September 13, 1991

Re: Review of 5 RODs

DRAFTING ENFORCEABLE RODS
AND STATEMENTS OF WORK

FIGURE 6

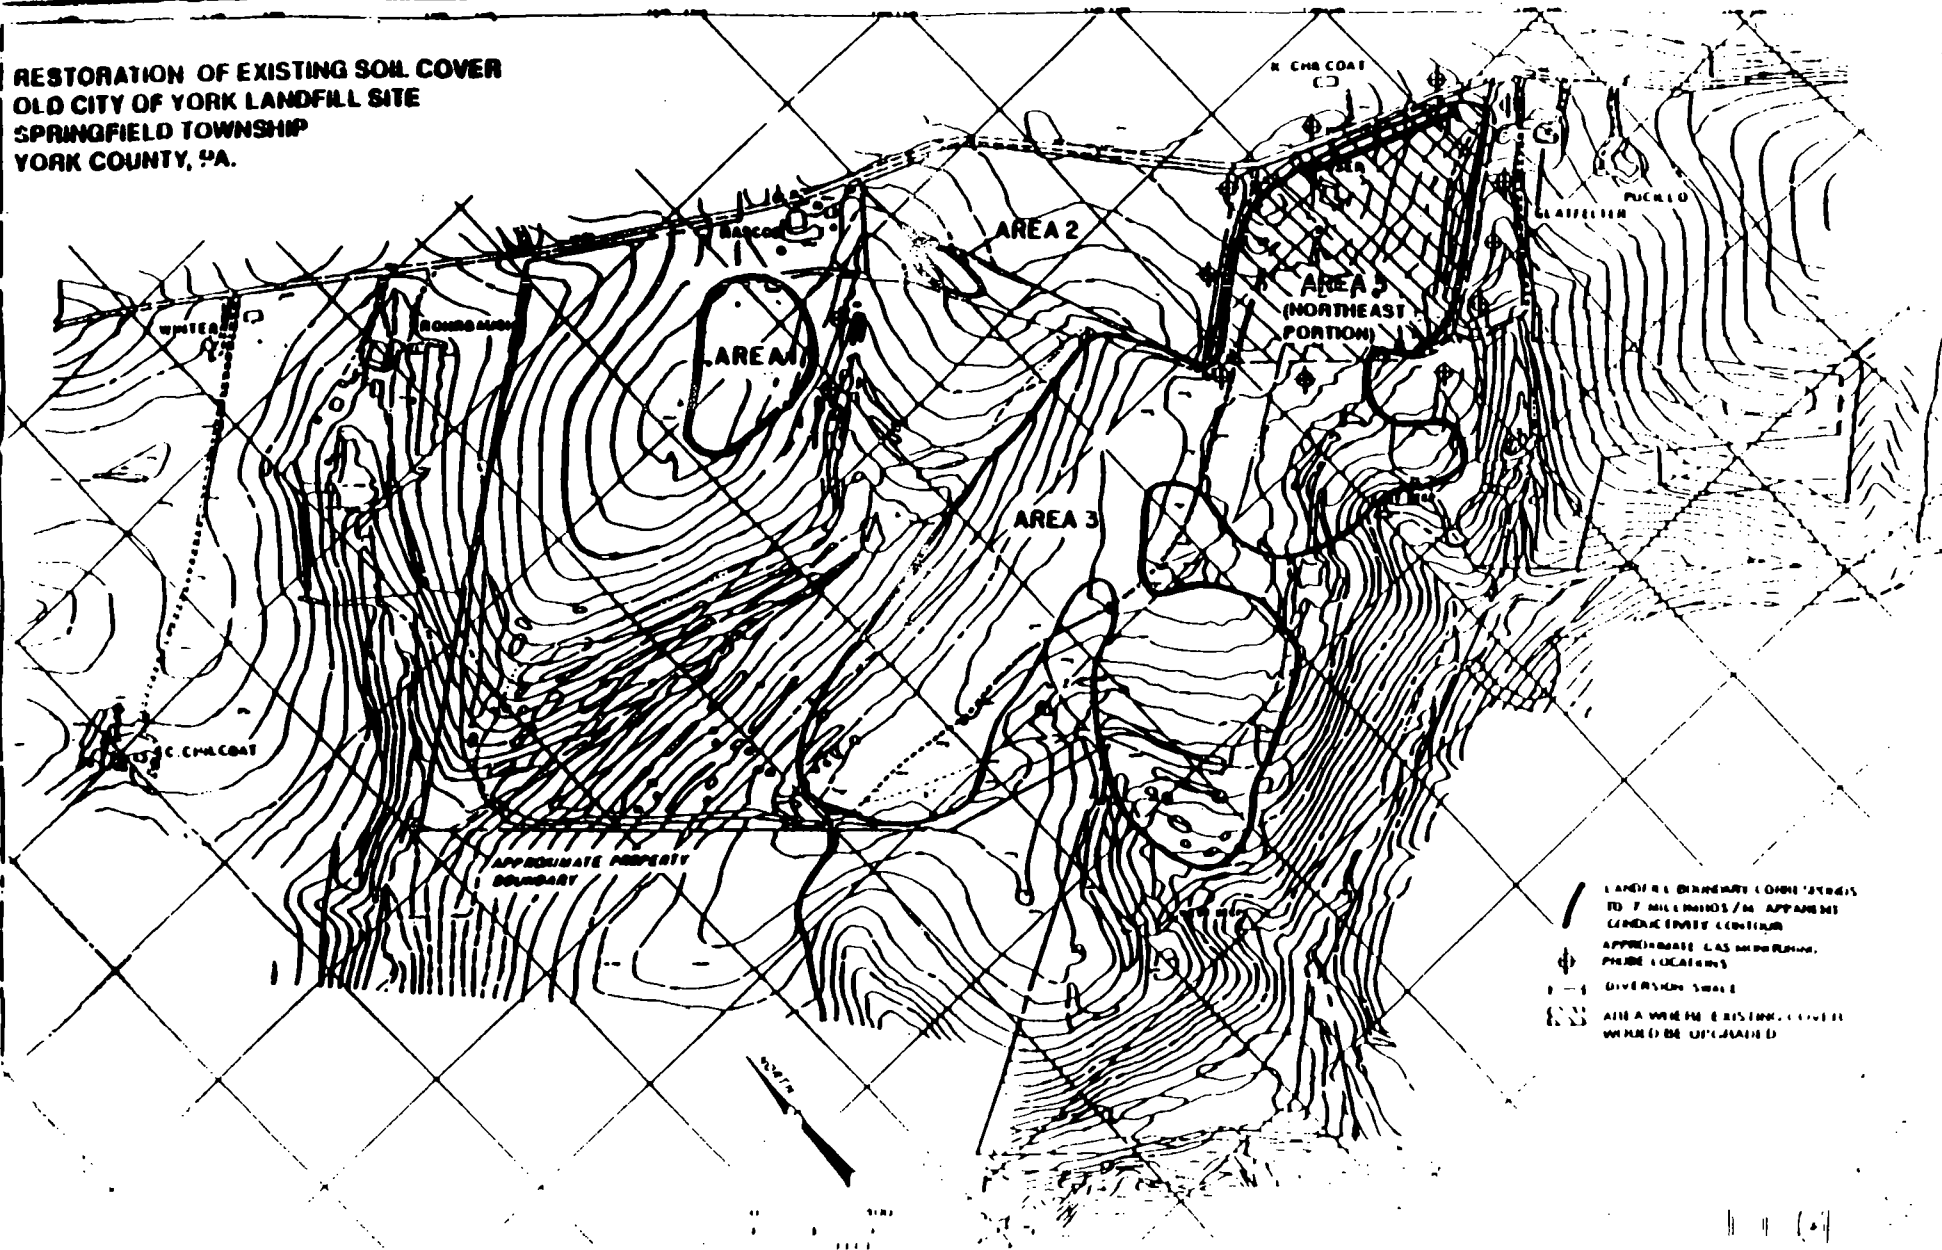
I ASSUME
YOU DON'T
WANT A
ROCKY CAP
OR
CAP

THESE 2
SENTENCES
ARE
INCONSISTENT

29
INCLUDE STANDARDS FOR EACH OF THE 5 ELEMENTS.
(1) CAP - ADD ANY ADDITIONAL REQUIREMENTS (I.E. MATERIALS, COMPACTION, GRADING, ETC) OR PERFORMANCE STANDARDS (I.E. PERMEABILITY ETC) (AFTER)

A uniform and compacted layer of soil shall be placed over the northeastern section of refuse Area #3 to restore the soil cover in this area to a two foot minimum. This soil cover shall (1) provide dermal protection from the refuse in the northeastern portion of Area #3; (2) be capable of supporting the germination of propagation of vegetative cover; and (3) compact well and not crack excessively when dry. The cover shall be maintained for 30 years.
